Bulletin No.: SB-033_00

Service Bulletin

Action required in relation to attention items as described by Hoerbiger Micro Fluid GmbH.

The release of safety related document of Hoerbiger Micro Fluid GmbH about hydraulic locking units.

Figure 3: information for LE32 and LE25 screw connection at the bottom.

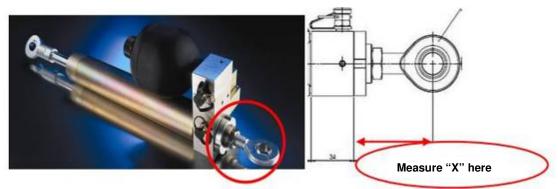
For the LE 32 versions the screw thread depth is correct when the rod end length "X" is below 65 mm. (X < 65mm)

For the LE 25 versions the screw thread depth is correct if the rod end length "X" is below the value as stated behind the product number in de table below. The small x at the end of the product number indicates the version number.

We strongly urge you to immediately check the measurement set out above on all Personal Restraint Systems in your possession and advise your technicians to adjust and maintain the measurements specified when installing the unit into a Personal Restraint System or during routine maintenance.

We recommend that the joint rod heads be secured at the specified dimensions and tightened with a torque wrench. The LE 25 version should be tightened to 80 Nm \pm 10 Nm. The LE 32 version should be tightened to 90 Nm \pm 10 Nm.

The correct measurement must be set and checked when installing or performing maintenance on the Cylinder Accumulator unit. In this way the required minimum screw thread depth engagement (as set out in VDI 2230) is maintained.
